Urgent Field Safety Notice
Molecular Diagnostics at Abbott
Product: Alinity m System
List Numbers: 08N53-002
Not Serial Specific
Unique Device Identifiers (UDIs): 00884999048034

March 19, 2024

FA-AM-MAR2024-298B

Appendix A

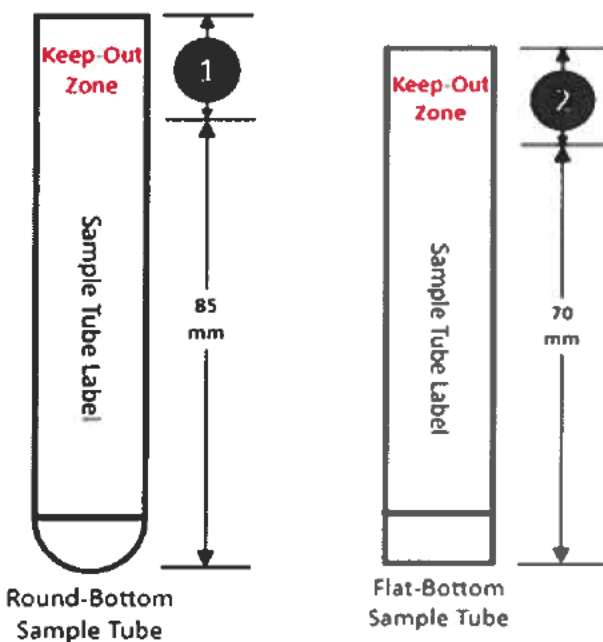
The Alinity m System camera detects whether tubes are “capped.” If the camera detects a cap and the retention bar is not present on the sample rack, the system will generate the message “Error – 6013: Has cap, no retention bar.” Any color other than black or white within the Keep-Out Zone (See Appendix A) on the tube label can cause the camera to falsely detect a cap, resulting in generation of the error code. Because this is an incorrectly generated error code, the corrective action associated with Message Code: 6013 of “Remove sample rack and add the retention bar with the rack” will not remediate the issue. The correct method to remediate this error code is outlined in the Necessary Actions section of this letter.

Aliquot the sample from the sample tube that is experiencing the error to a different sample tube, as permitted by the assay package insert, and ensure the following sample tube label requirements are met:

1. This area defined as ① is the keep-out zone for the round-bottom sample tube. The keep-out zone is the area where the sample tube label cannot contain colors other than white and black, above a maximum of 85 mm from the bottom of the tube.
2. The area defined as ② is the keep-out zone for the flat-bottom sample tube. The keep-out zone is the area where the sample tube label cannot contain colors other than white and black, above a maximum of 70 mm from the bottom of the tube.
